# Technical Service Bulletin

SUBJECT:		No:	<b>TSB-22-54-002</b>
<b>SOFTWARE UPDATE FOR SMARTPHONE LINK DISPLAY AUDIO</b>		DATE:	<b>March 2022</b>
		MODEL:	<b>See below</b>
<b>CIRCULATE TO:</b>	<input type="checkbox"/> GENERAL MANAGER	<input checked="" type="checkbox"/> PARTS MANAGER	<input checked="" type="checkbox"/> TECHNICIAN
<input checked="" type="checkbox"/> SERVICE ADVISOR	<input checked="" type="checkbox"/> SERVICE MANAGER	<input checked="" type="checkbox"/> WARRANTY PROCESSOR	<input type="checkbox"/> SALES MANAGER

A software update is now available for the Smartphone Link Display Audio (SDA). This update resolves several issues that may occur in various models equipped with SDA, as listed below.

## DISPLAY AUDIO SOFTWARE VERSION CHART

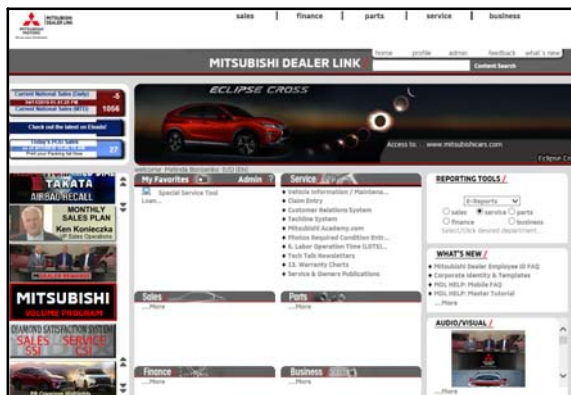
Model	Software Version		
	<New>	<Old>	Update file name
2020-21 Outlander 2020-21 Outlander PHEV 2020-21 Outlander Sport/ RVR	<b>#5.5</b>  (1) H/W ver $\leq$ "0008" MCU Version : 0.3300.P100 SoC Version : 0.3300.P101	<b>#4.39</b>  MCU Version : 0.0087.P000 SoC Version : 0.0087.P000	<b>SDA without Navigation</b>
